Modification to run CPU09CMI on 4MHz bus.

Now we need the Q clock on the 09FLP

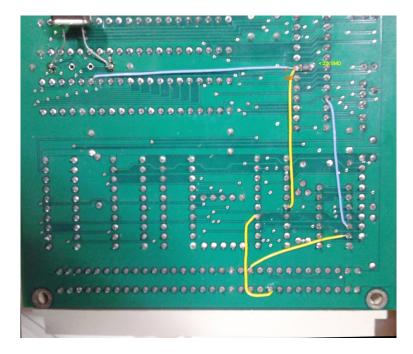
Replace xtal into 16MHz. Replace C1 and C2 by 15pF. Replace GAL CMI_1 by CMI-4_1 Only use the HD63C09.

On top side:

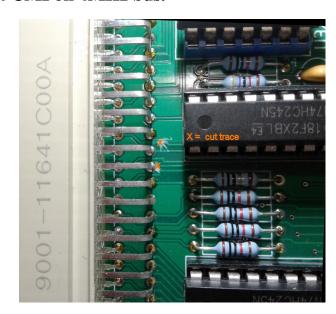
Cut trace between U4-14 and J1 C-21 (B_VMA) For REV:0.9 print only cut trace from J1 A23 to R15

Cut trace between U13-19 and via (OVMA) Place 22K resistor between U13-19 and Gnd Place wire from U6-35 to U13-19 and U4-6 (Q) Place wire from U4-14 to J1 A-23 (B_Q)

To keep CPUxxCMI 6802 compatible: On top side:

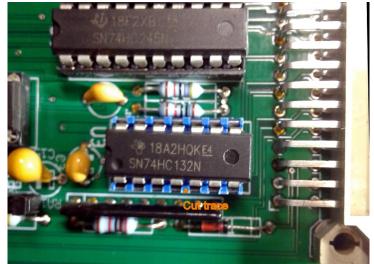
Cut trace between U3-4 and U3-5

Place wire from U3-5 to U13-9 (VMA) Place wire from U3-6 to J1 C-21 (B_VMA)
